SECOND FLOOR PLAN
SCALE: 1/4"=1'-0"
8'-0" C.L.S. HGT.
SET WINDOWS AT 6'-8" A.F.F.

TRIANGLE DEALS, LLC
"THE DRAIME"

PLAN NO.
DK2618

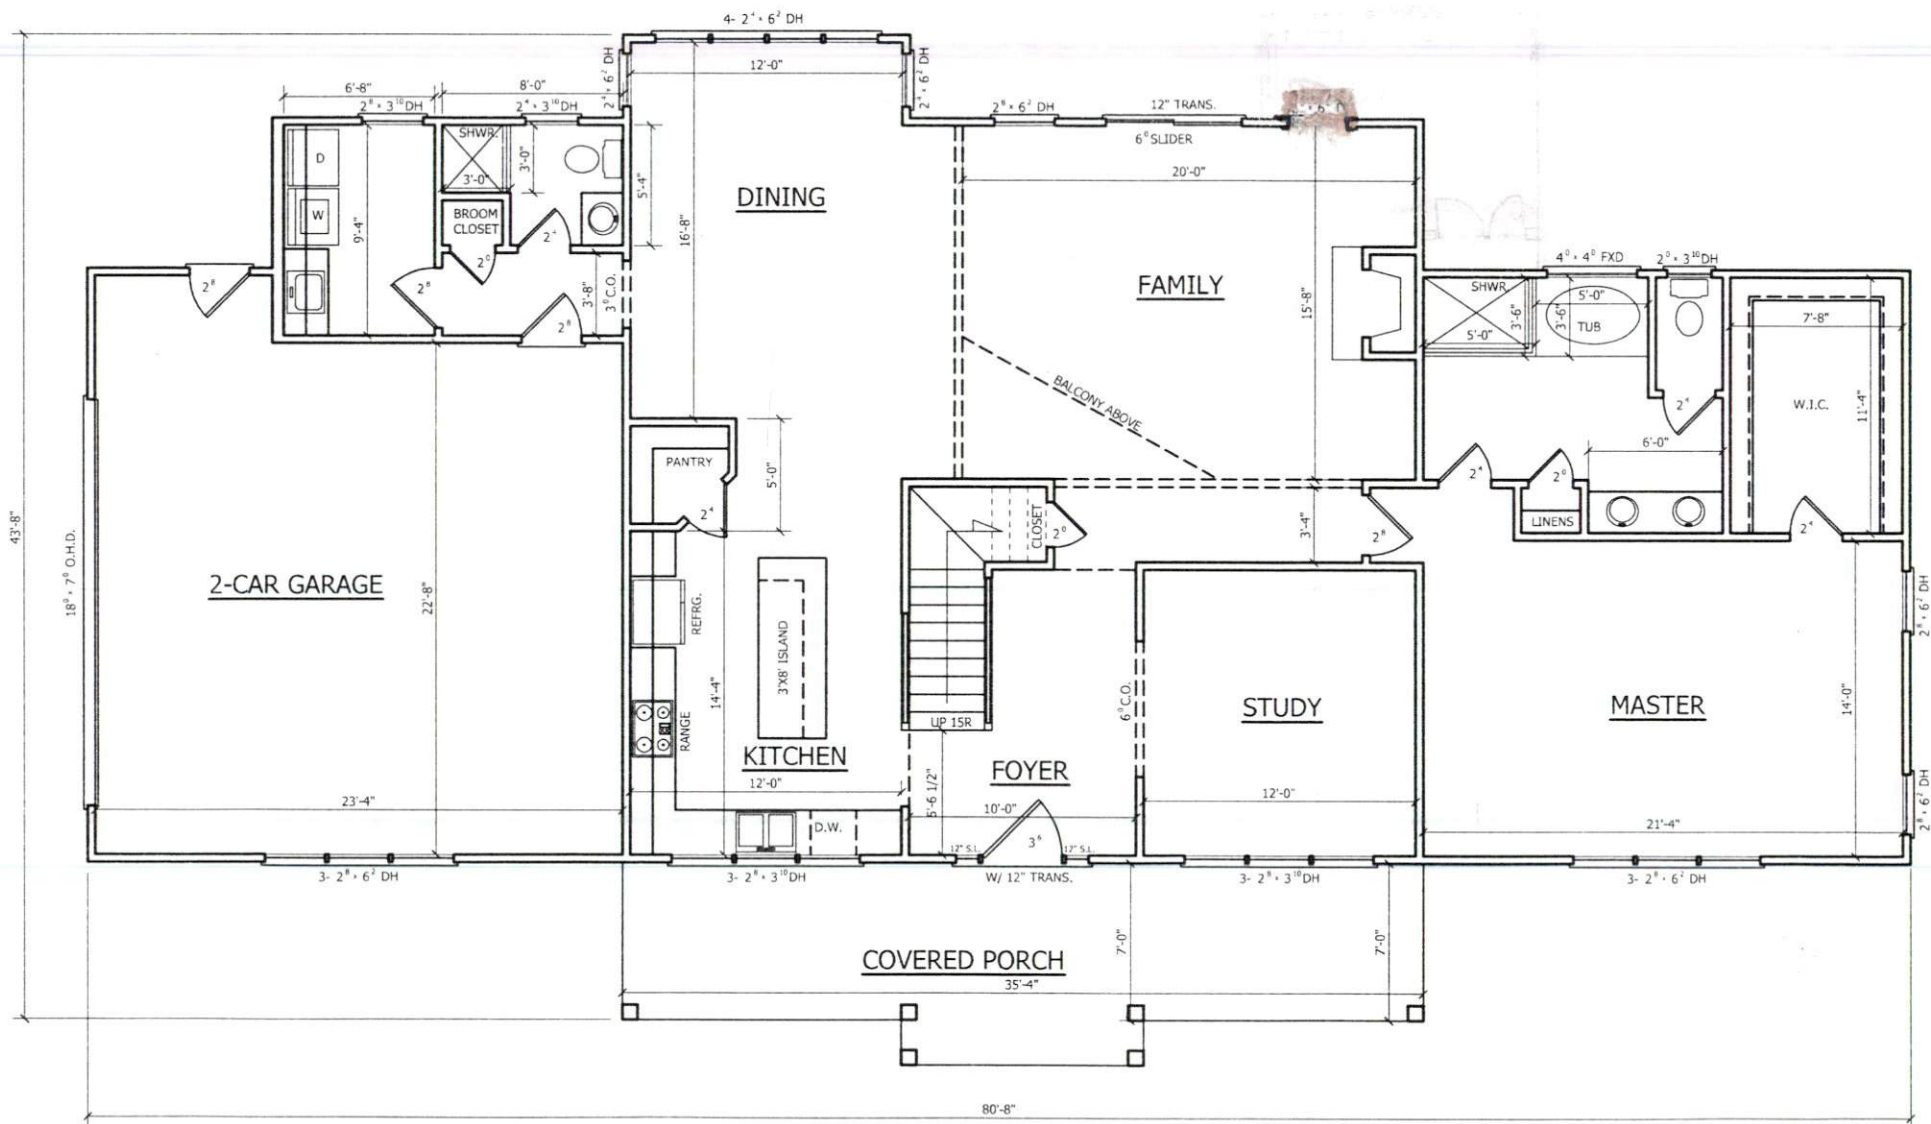
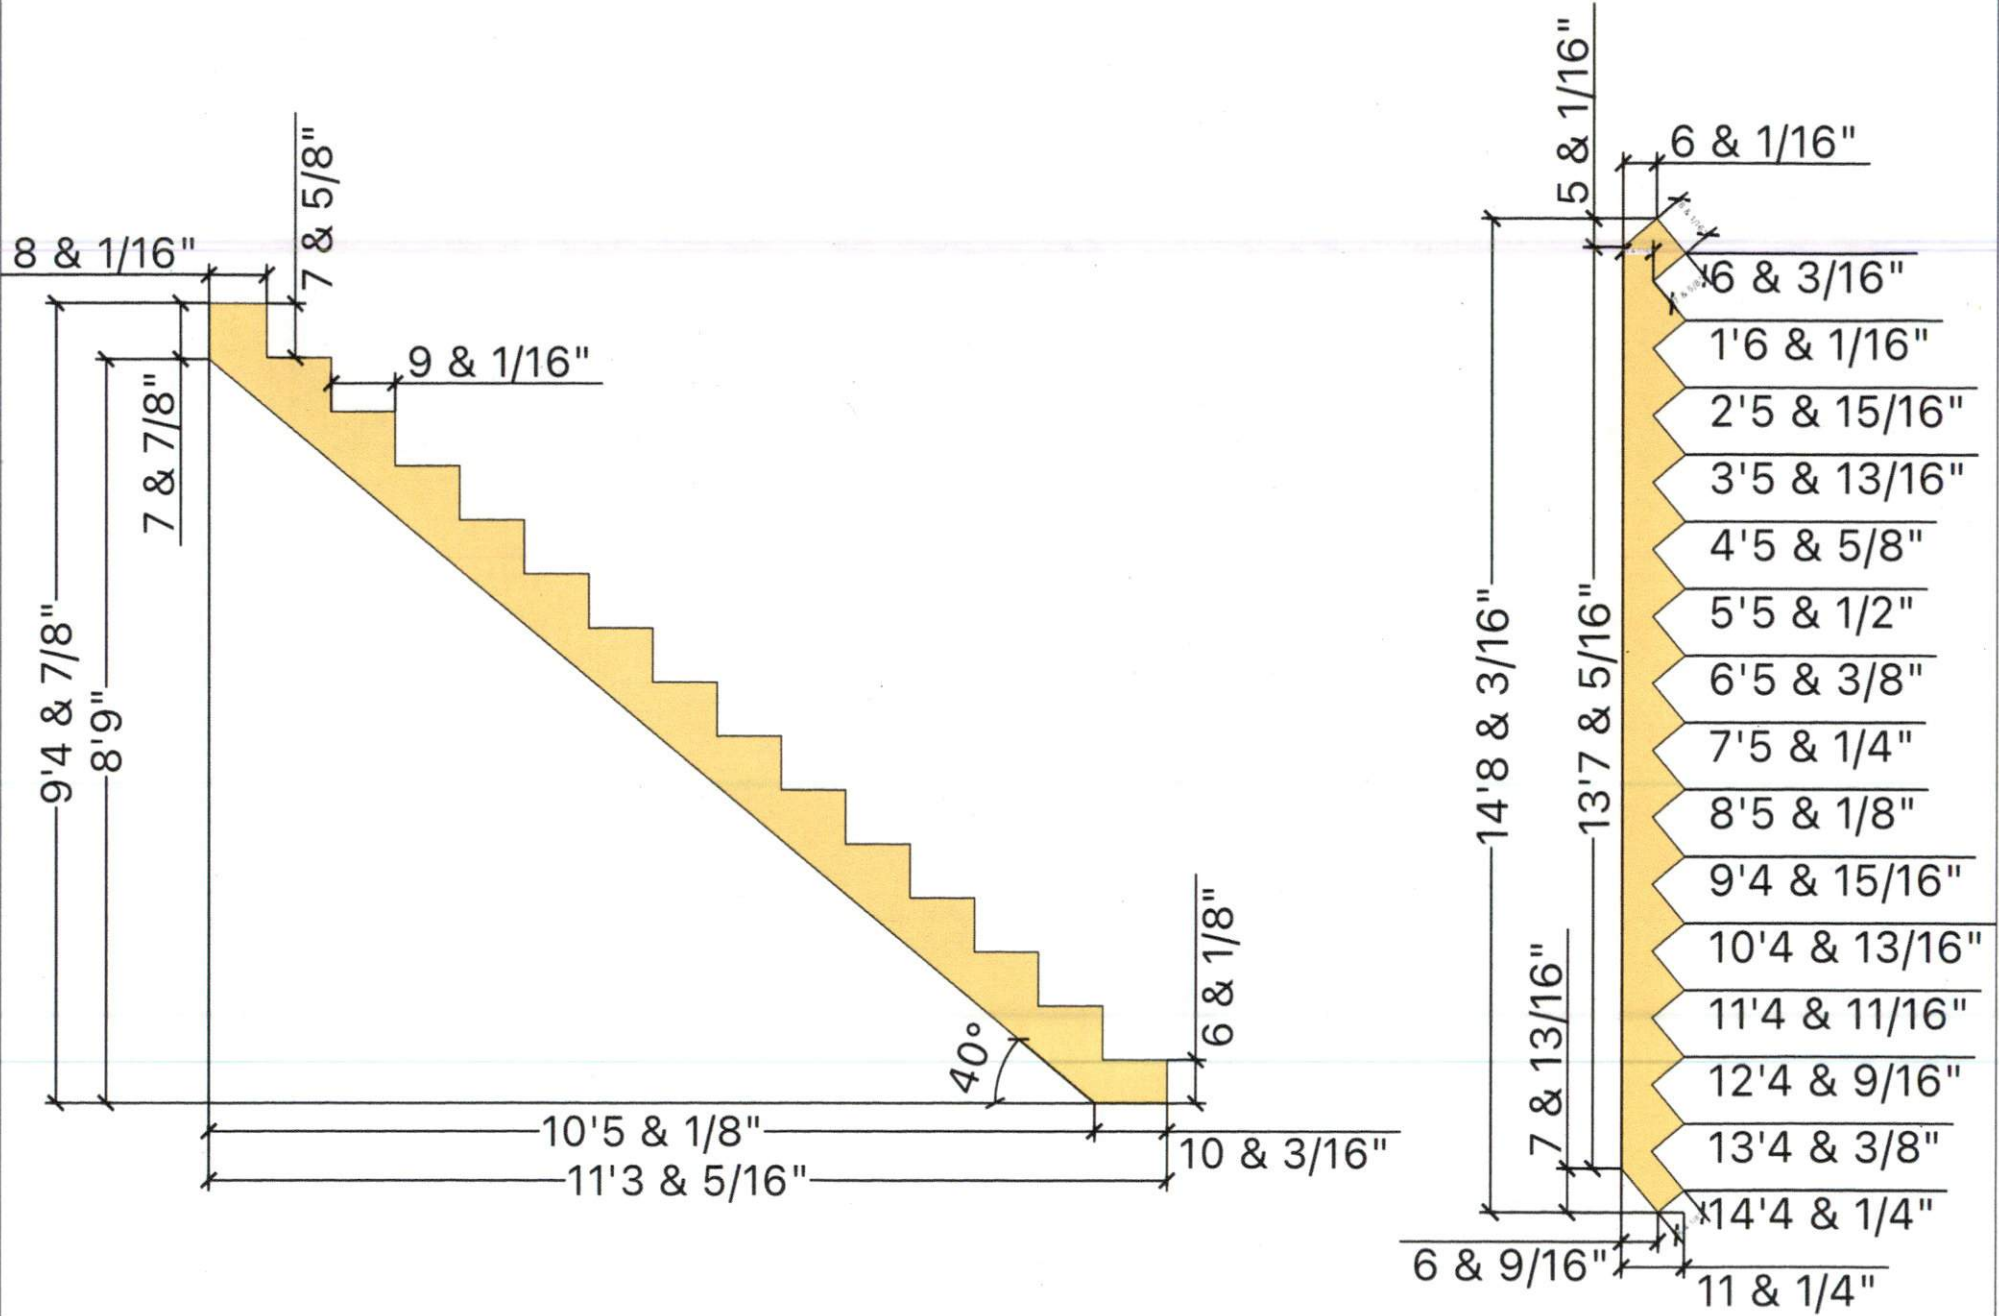
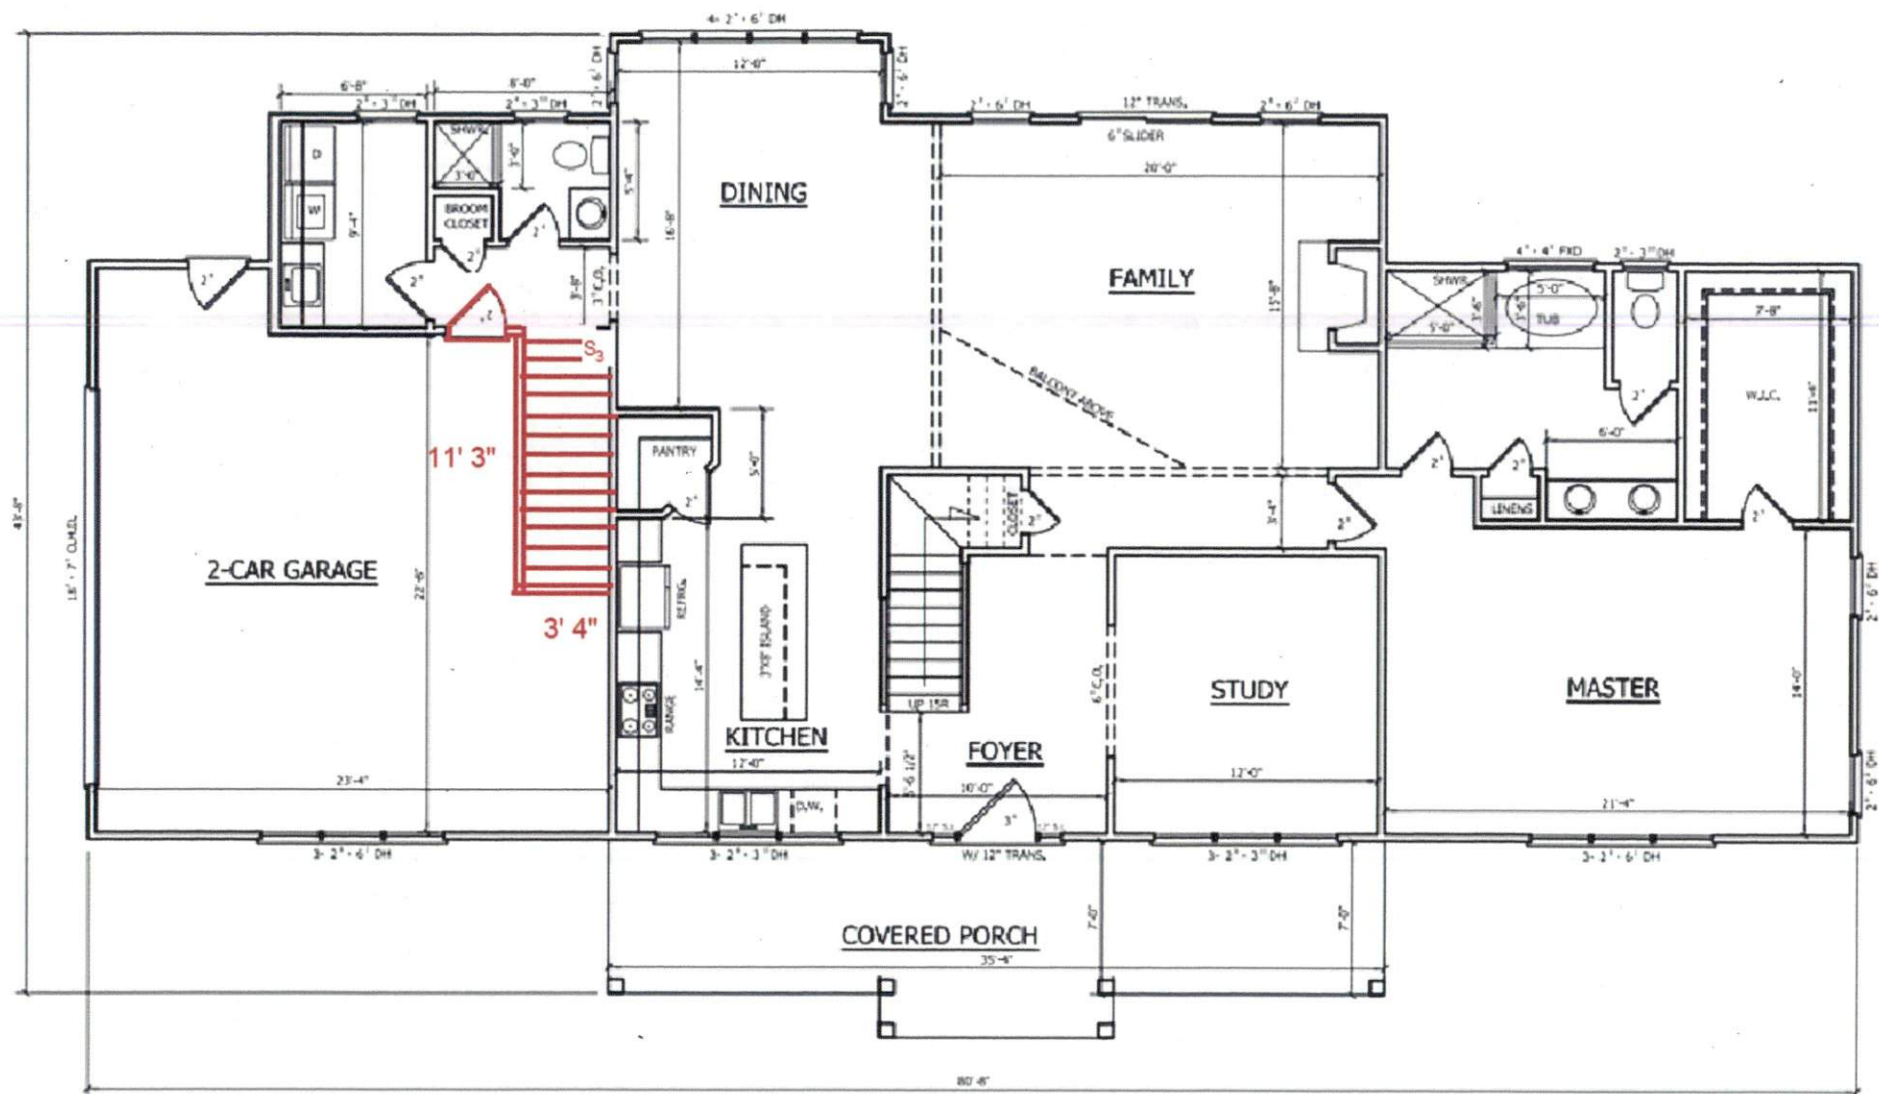
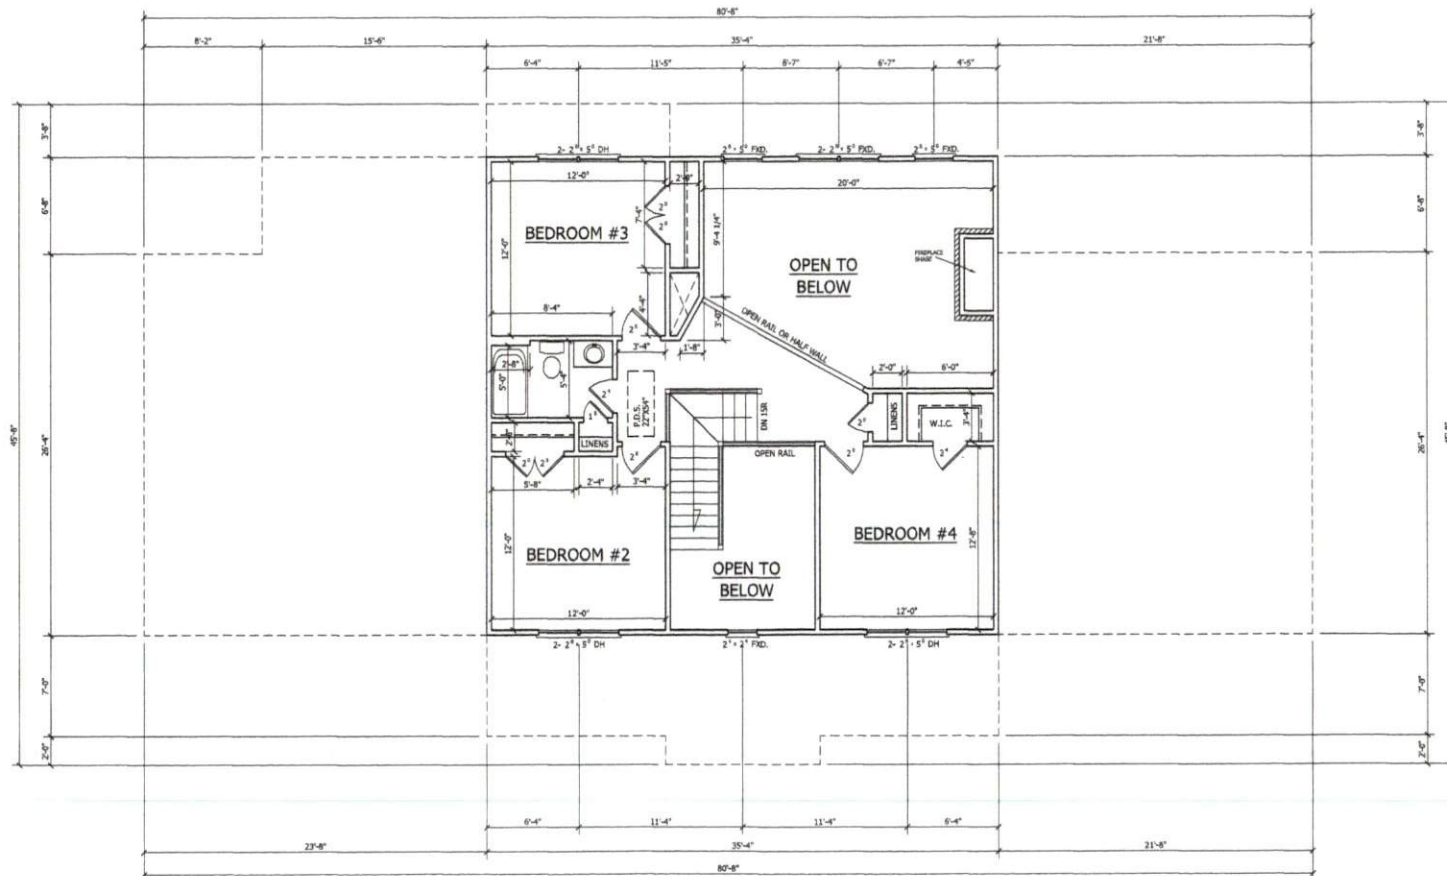
Install code complaint footings in existing slab to support header. Cut joists shall be attached to header with proper I joist hangers. Footing for beam support must be inspected prior to pour. Top of stairs shall have 3x3 landing. All of staircase including landing shall have not less than 6'8" clear headroom. Stair case shall be fire separated from garage. Must have interconnected smoke detector in play room. Must have code compliant egress window in playroom.

TJI Floor joist
3'8"
cut 2 TJI and
header off
for ac
